## Change in Wafer Fabrication Facility for XC95144XL and XC9572XL CPLDs

XC�05003 (v1.0) January 31, 2005

Product/Process Change Notice

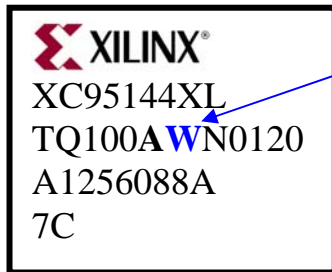
These devices can be distinguished by the second letter in the 3-letter code located in the middle of the second line of the package topmark. The 2<sup>nd</sup> letter is “W” for product fabricated at He Jian, and ‘M’ for product fabricated at UMC. Please reference the diagram below.

### Fab Code:

M = UMC, Taiwan

W = He Jian, China
